SUBJECT: Forwards info responding to questions re QA program & provides program update reflecting QA responsibility for preliminary testing. Info will be incorporated in Nov 1984 FSAR amend.

Re: Nine Mile Point Unit 2
Docket No. 50-410

Nine Mile Point Unit 2 FSAR

Figure 17.1-2

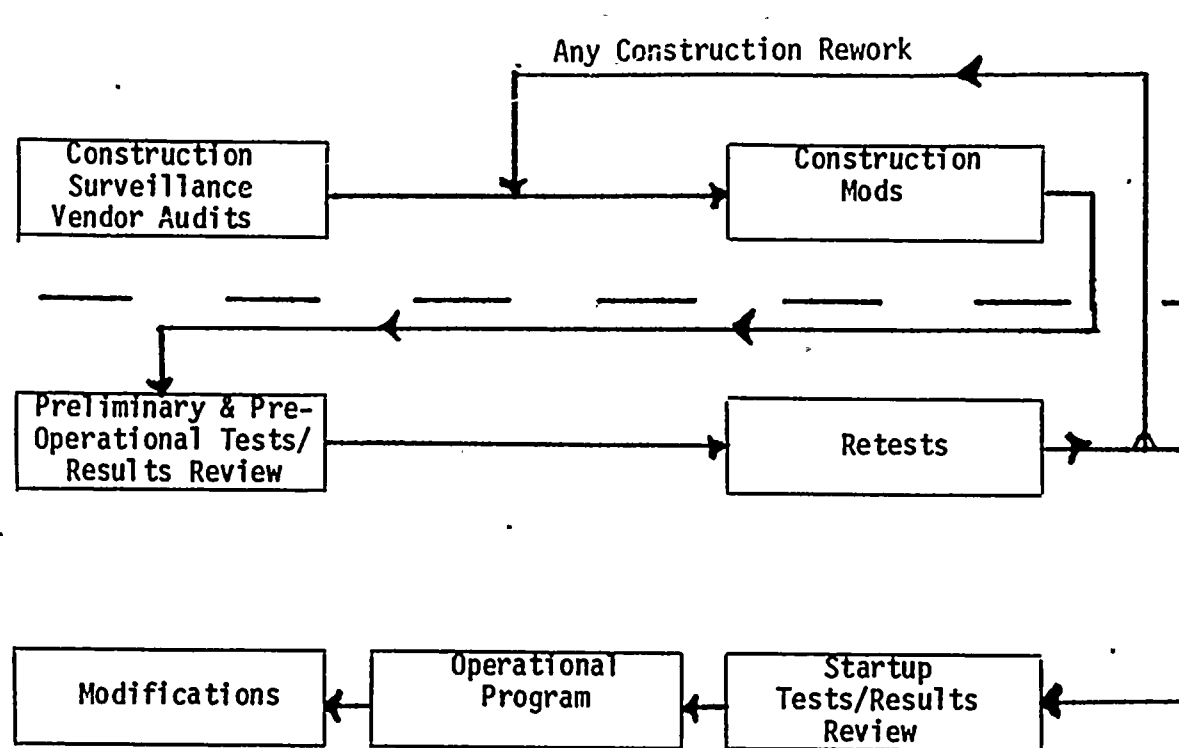
1. This line designates the applicable QA Manager and QA Program.

APPLICABLE QA PROGRAM AND ORGANIZATION
USED DURING PRELIMINARY TESTING/CON-
STRUCTION, PREOPERATIONAL TESTING AND
STARTUP TESTING/OPERATIONS
